# Submissions and Amendment Report

Residential Development  
with Affordable Housing  
at East Walker Street, North Sydney

173-179 Walker Street and  
11-17 Hampden Street, North Sydney

SSD-67175465

**Figure 2** Amended building footprints and Setbacks for the Amended Development

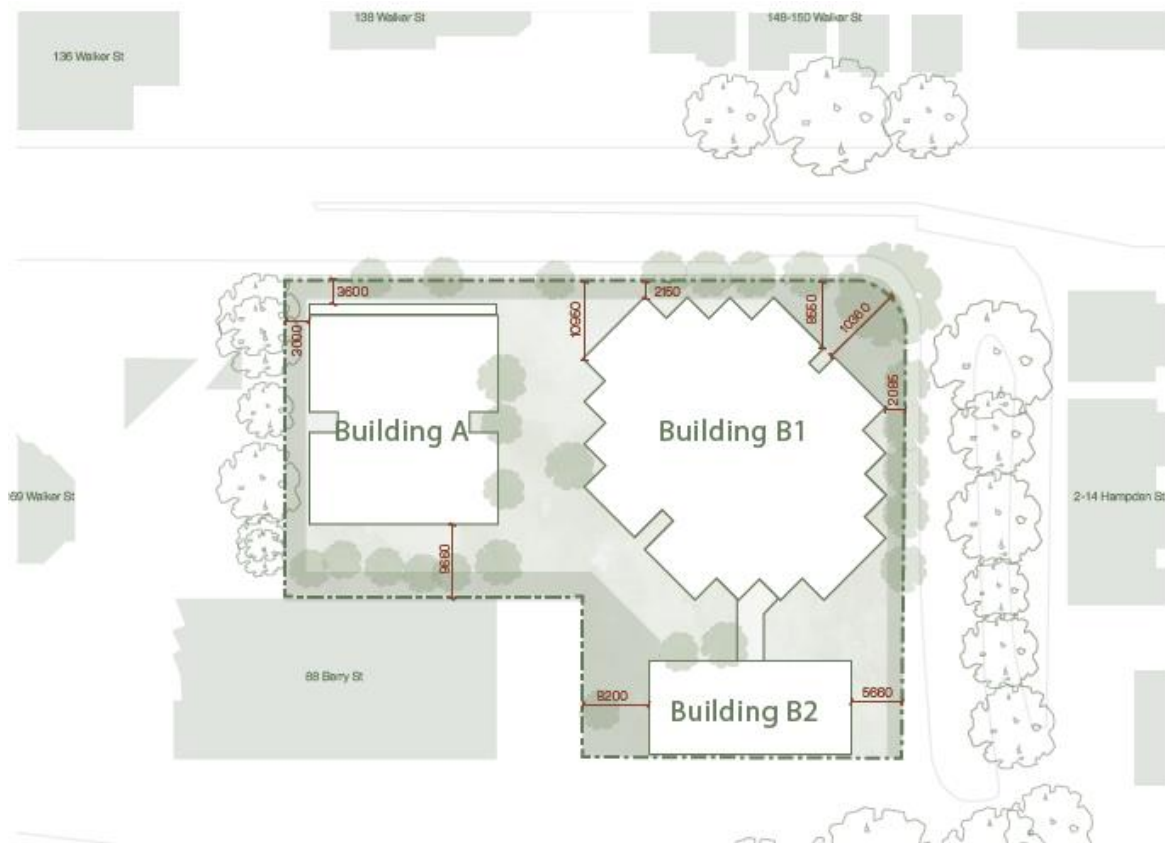
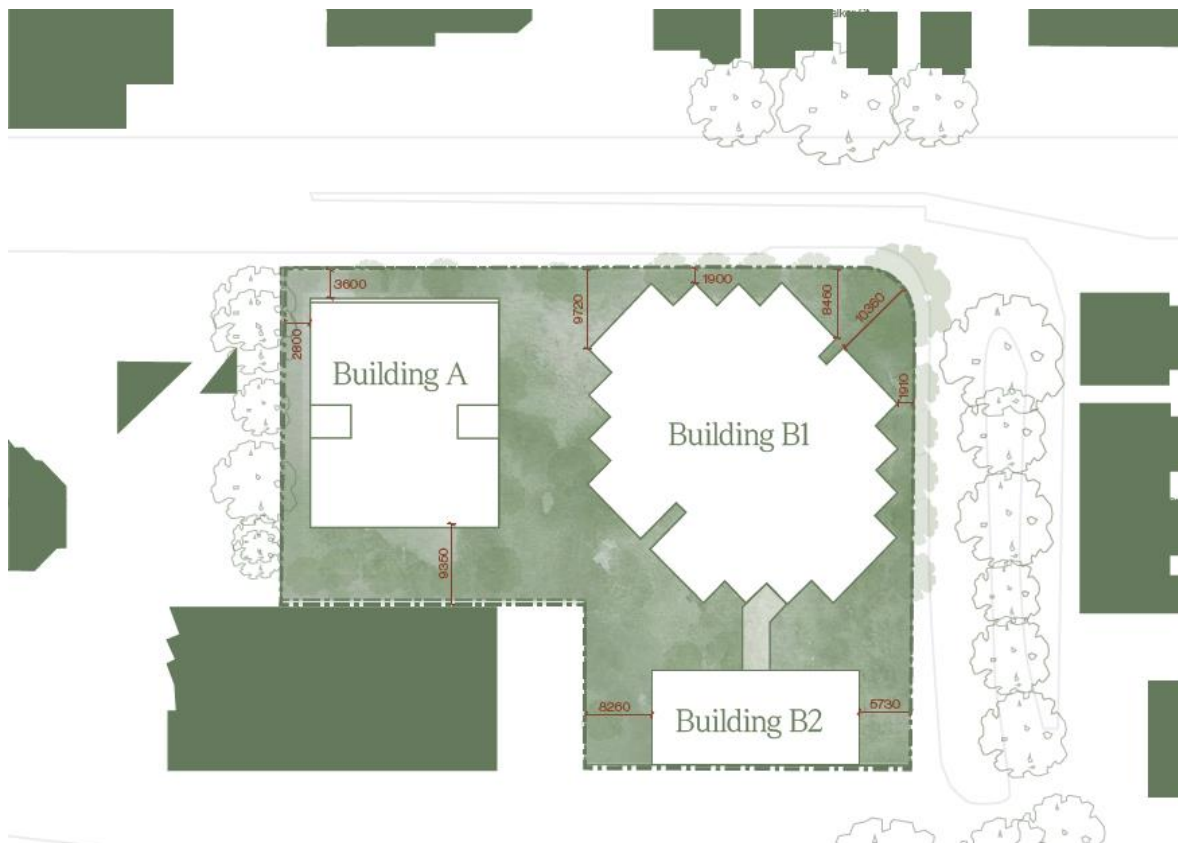
Building B1 shifted up to 442mm north and up to 107mm west to allow for setback tolerances to the southern and eastern vertical height plane, with the building footprint adjusted accordingly. This is illustrated below.

**Figure 4** Amended stormwater diversion alignment

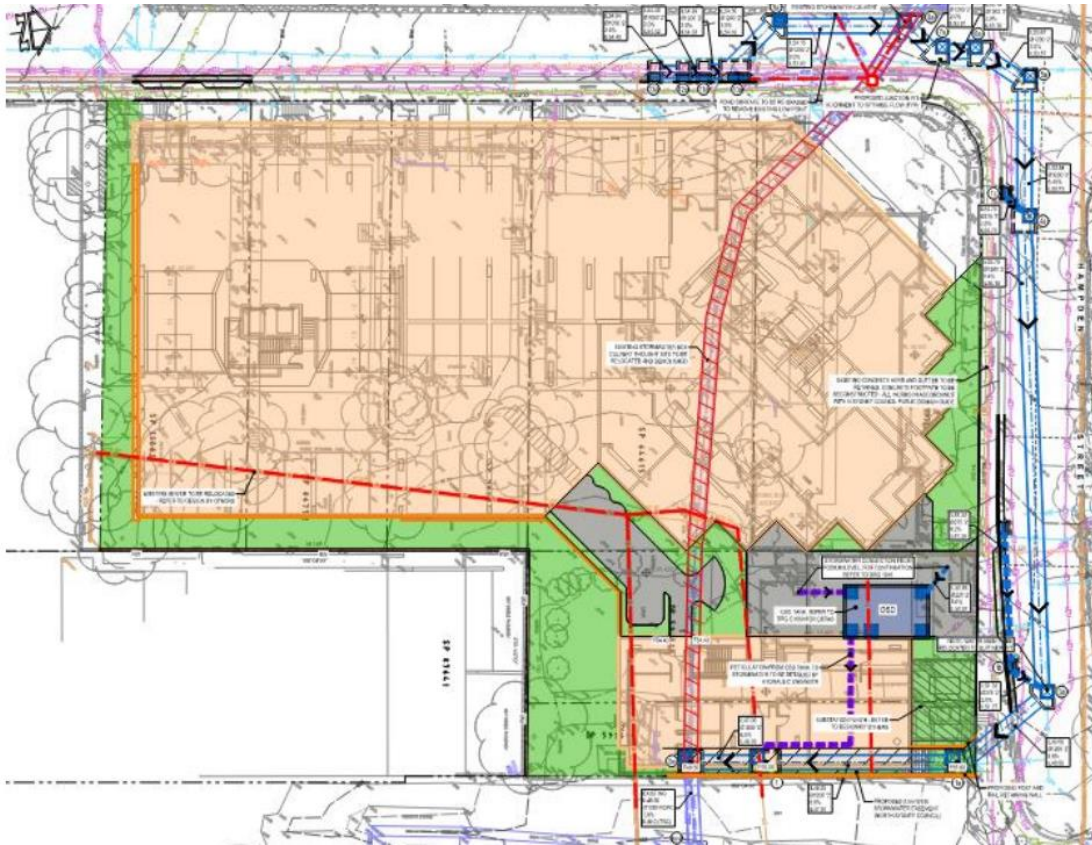
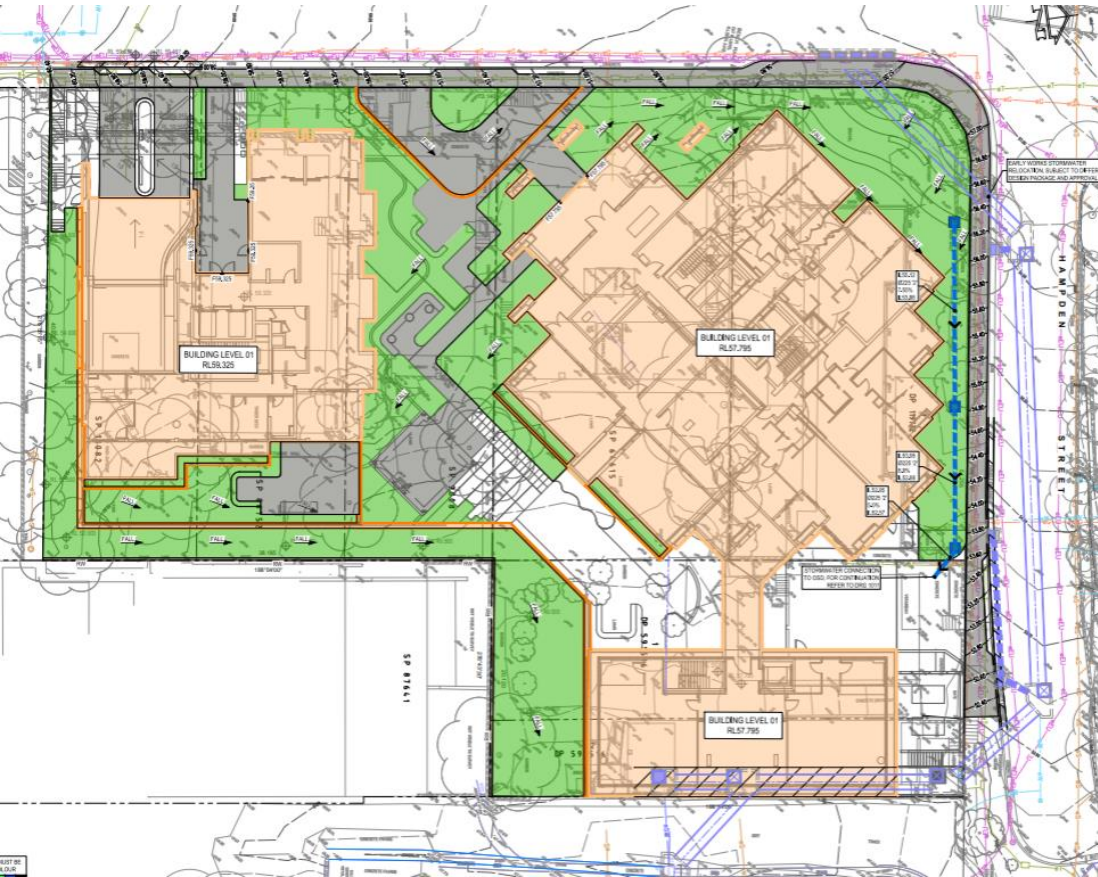
Landscape Design	Updated landscape design to coordinate with architectural changes and proposed Northwest stormwater easement at the ground plane.
<b>Stormwater Diversion</b>	
Alignment of Stormwater Diversion	<p>Updated alignment of the stormwater diversion to run within a proposed new easement located on the Northwest corner of the site. The alignment of the stormwater diversion is proposed to sit within the existing rock level. Landscaping above is limited to seating which can be removed by lifting hooks.</p> <p>The updated alignment also proposes a stormwater diversion that traverses the adjacent TfNSW owned land (Warringah Freeway/Western Harbour Tunnel works) site at a 45-degree angle to connect into the existing stormwater pit on the TfNSW site.</p> <p>A comparison of the originally proposed and amended stormwater diversion alignment is shown in <b>Figure 3</b> and <b>Figure 4</b>.</p>

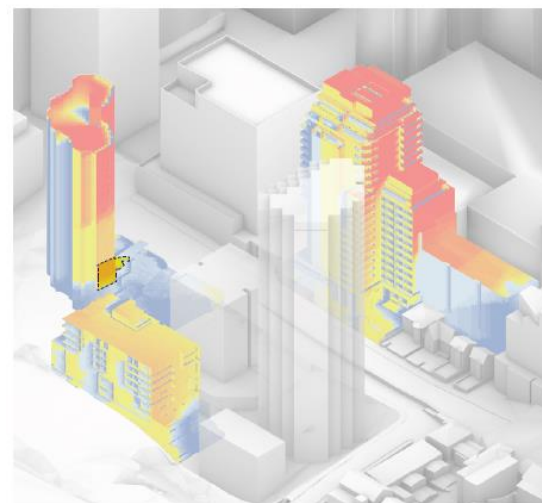
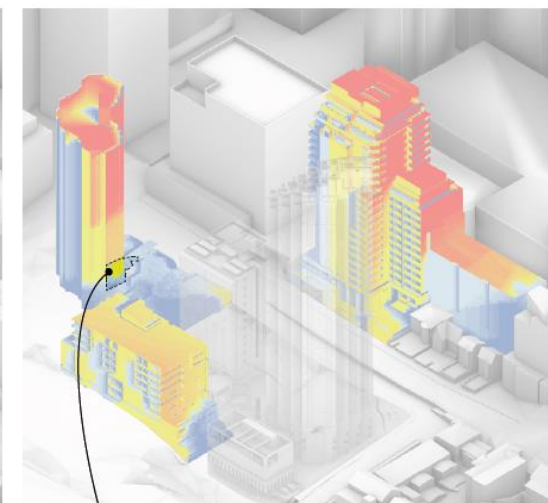
Summary of Matters Raised		Responses
Visual Analysis/Overshadowing (Economic, Environmental and Social Impacts)		
DPHI-2	Community submissions raised concern about the overshadowing impacts as a result of applying the 30% bonus building height above the North Sydney Local Environmental Plan 2013 (LEP) building height control applicable to the site	Noted.
	<p>In responding to these concerns, please provide:</p> <ul style="list-style-type: none"> <li>a detailed analysis of potential midwinter overshadowing impacts to neighbouring residential properties and associated private open space to the south and south-east, including elevational shadow diagrams where necessary.</li> </ul>	<p>The Architectural Plans prepared by Rothelowman (<b>Appendix F</b>) and RTS Design Report (<b>Appendix G</b>) have been updated with detailed solar studies for apartments in 138 Walker Street to the west, 171 Walker Street to the south, and 88 Berry Street to the south/east. These studies compare proposed solar impacts to the existing conditions, a DCP/LEP compliant envelope, and the proposed envelope excluding the 30% height bonus.</p> <p>In summary, the impacts are to neighbouring residences in mid-winter are:</p> <ul style="list-style-type: none"> <li>6% reduction in sunlight to one living room of 138 Walker Street for one hour</li> <li>Up to 2 hours of additional shading of bedrooms, bathrooms, and secondary balconies (accessed off bedroom) to 10 apartments in 171 Walker Street</li> <li>Reduced sunlight to one private open space to 171 Walker Street for 1 hour. This space will still achieve 2 hours of direct sunlight</li> <li>Improved solar access to 12 apartments in 88 Berry Street – additional 3 hours of sunlight due to the reduced form of Building B2 compared to the LEP permitted height.</li> </ul> <p>Refer to <b>Section 5.4.2</b> and RTS Design Report (<b>Appendix G</b>) for a detailed response.</p>

<ul style="list-style-type: none"> <li>comparison plans and analysis which demonstrate the additional shadows on the affected properties to the south and south-east due to proposed additional building height sought under the Housing SEPP bonus provisions.</li> </ul>	<p>Comparison plans and analysis showing the additional shadows on the affected properties to the south and south-east due to proposed additional building height sought under the Housing SEPP bonus provisions are provided in the diagrams within the RTS Design Report (<b>Appendix G</b>).</p> <p>In summary, additional overshadowing generated by parts of the building that utilise the additional height provided by the Housing SEPP bonus are limited to the lower levels of 171 Walker Street which have their solar access on 21 June reduced from 4 hours to 2 hours or less, though these areas within 171 Walker Street are limited to kitchens, secondary private open space and bedrooms, which are not protected by overshadowing controls of the Apartment Design Guide.</p>

**Figure 5** Heat map showing improved solar access to 88 Berry northern façade compared to compliant envelope

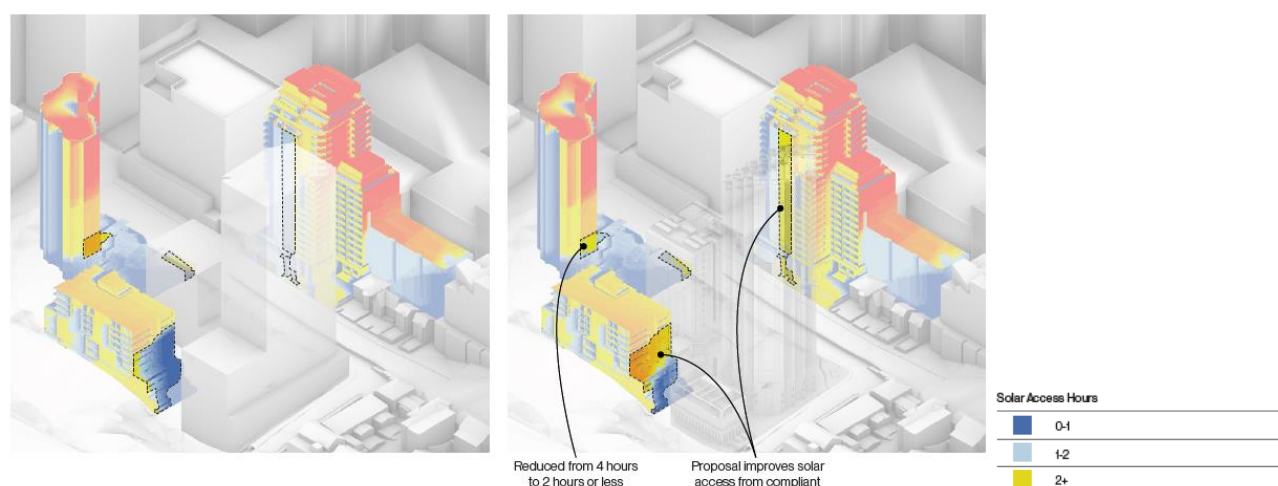
Solar access is maximised in the proposed development by the height of Building B2 being some 20m below the maximum height for Building B2 excluding the Housing SEPP height bonus (refer to **Figure 5**). This results in improved solar access to 12 apartments along the northern façade of 88 Berry Street, providing an additional 3 hours of solar access due to the reduced form of Building B2 compared to the LEP permitted height.

**Figure 7** Diagrams showing additional overshadowing generated by parts of the building within 30% height bonus

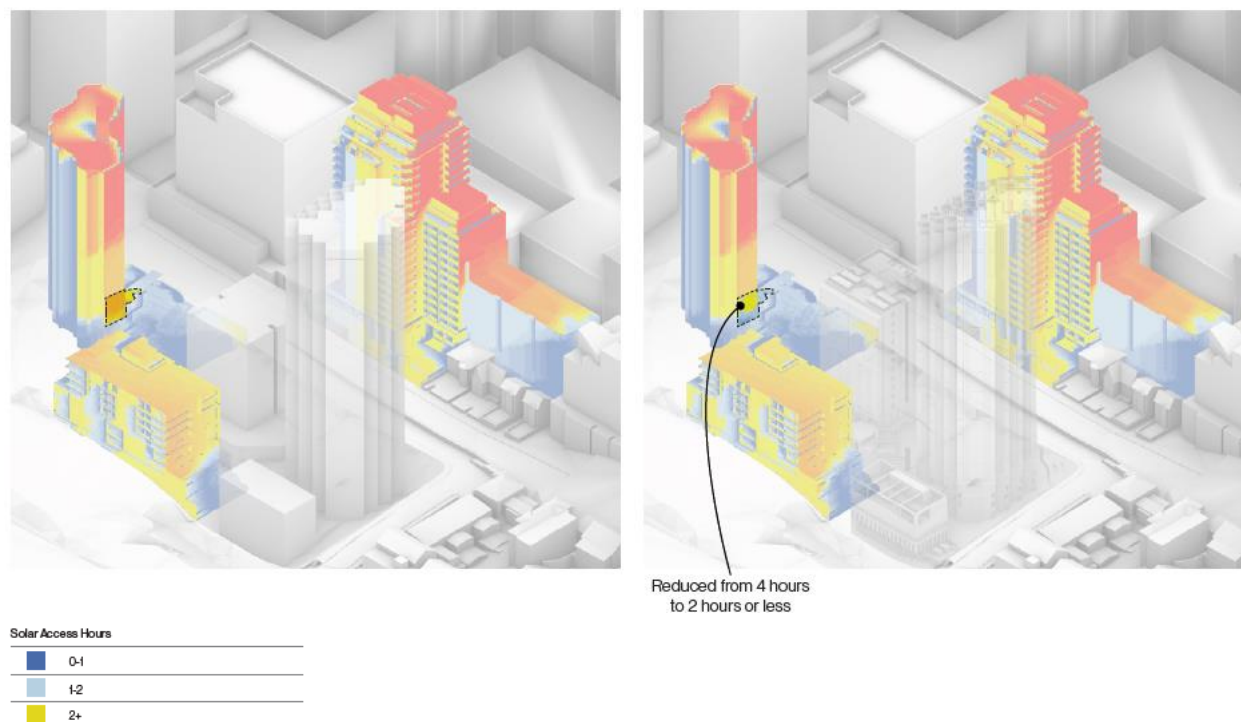
From 10am-2pm on 21 June, the parts of the development that utilise the additional height provided by the height bonus (Levels 10-12 of Building A, and Level 28-30 of Building B1) will result in up to 2 hours of additional shading of bedrooms, bathrooms, and secondary balconies (accessed off bedroom) to 10 apartments (refer to **Figure 7** below). However, bedrooms, bathrooms and secondary private open spaces are not spaces which the ADG seeks to preserve solar access to, and therefore impact to them is reasonable, especially within a dense urban environment.

**Figure 10** *Diagrams showing improved solar access outcomes compared to compliant envelope (see extent of pink shadow beyond the grey shadow)*

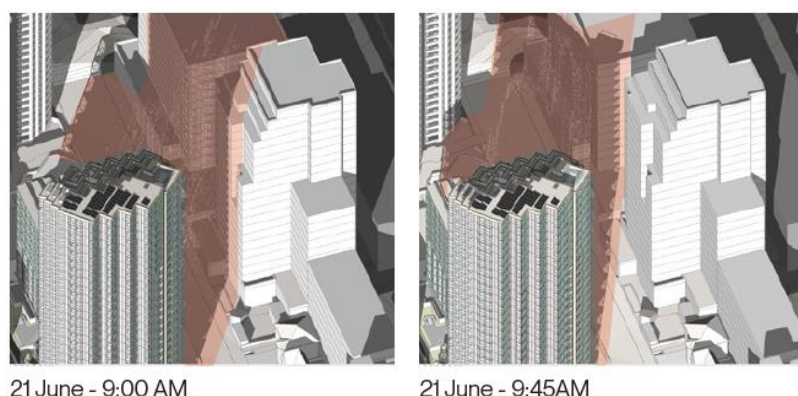
The significant improvements compared a development which utilises the maximum planning envelope is due to the generous setback of over 10m to Building B1 at the north-western corner of the site, which minimises overshadowing to 138 Walker Street from 9am-9:45am (refer to pink shadows beyond the grey shadows showing additional shadow generated by the compliant in **Figure 10** below).

**Figure 11** Section showing ADG visual privacy recommended setbacks to 88 Berry Street

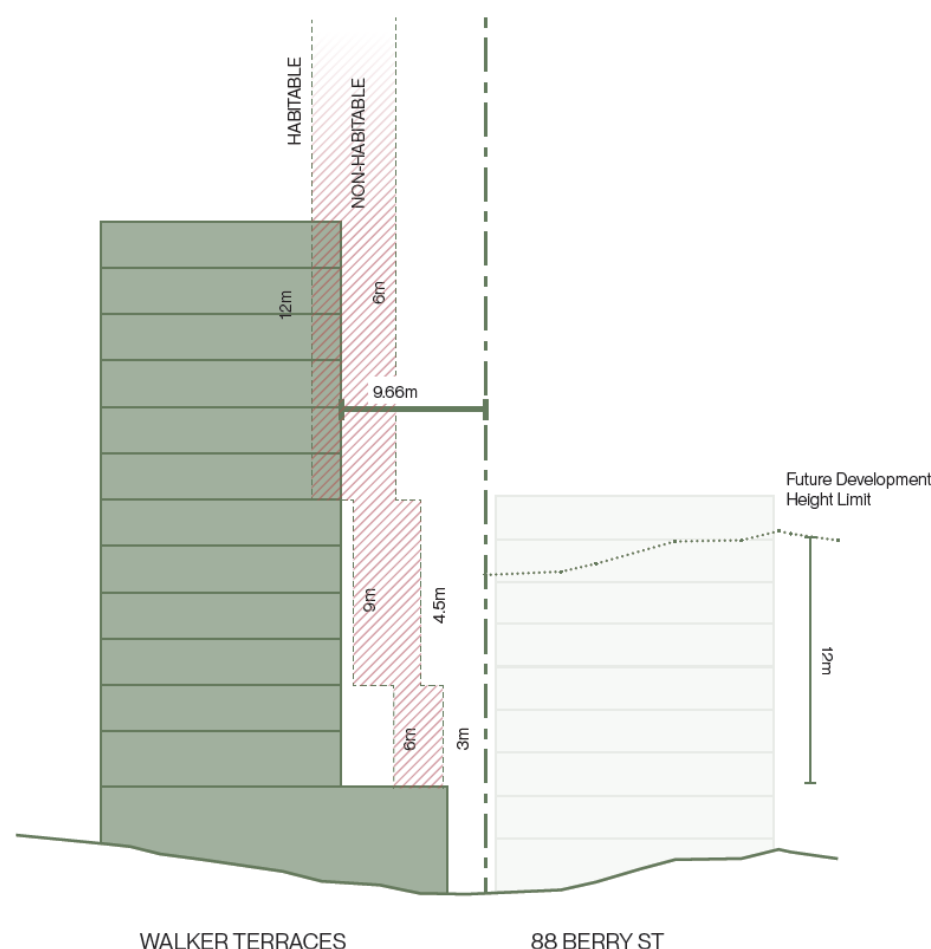
The eastern façade of all habitable rooms within Building A are setback 9.66m from the rear boundary to 88 Berry Street. It is noted that even though 88 Berry Street is built to boundary, the ADG specifies that building separation should be shared equitably and that any existing shortfall on an adjoining property does not need to be made up for or compensated for a new development site. As shown in **Figure 11**, up to Level 2 (12m) the proposal complies with the 6m habitable room setback, Levels 3-6 (height up to 25m), the proposal complies with the 9m habitable room setback. Notwithstanding, given the close proximity to 88 Berry Street which is built to boundary, the proposal has sought to include angled facades to ensure high amenity for current and future residents. A plan and section of the angled facades are shown at **Figure 11**. The eastern facade will contain opaque glazing panels up to standing height for visual privacy, with a clear fixed glazing panel above standing height to provide solar access. A smaller glazing panel angled towards the north-east allows for oblique views to the north-east past 88 Berry Street

As shown in **Figure 11**, the upper half of the building from Levels 7-12 is above the roof line of 88 Berry Street and therefore is not similarly impacted by visual privacy constraints. Therefore, a variation to the 12m ADG recommended setback is acceptable as 88 Berry Street has a height control of 12m, meaning future development would be limited in height to the equivalent of Level 2 in Building A, due to the fall of the land. Notwithstanding, the amended development includes opaque spandrel glazing to the lower extents of the Level 7-12 east-facing windows, further enhancing visual privacy outcomes.
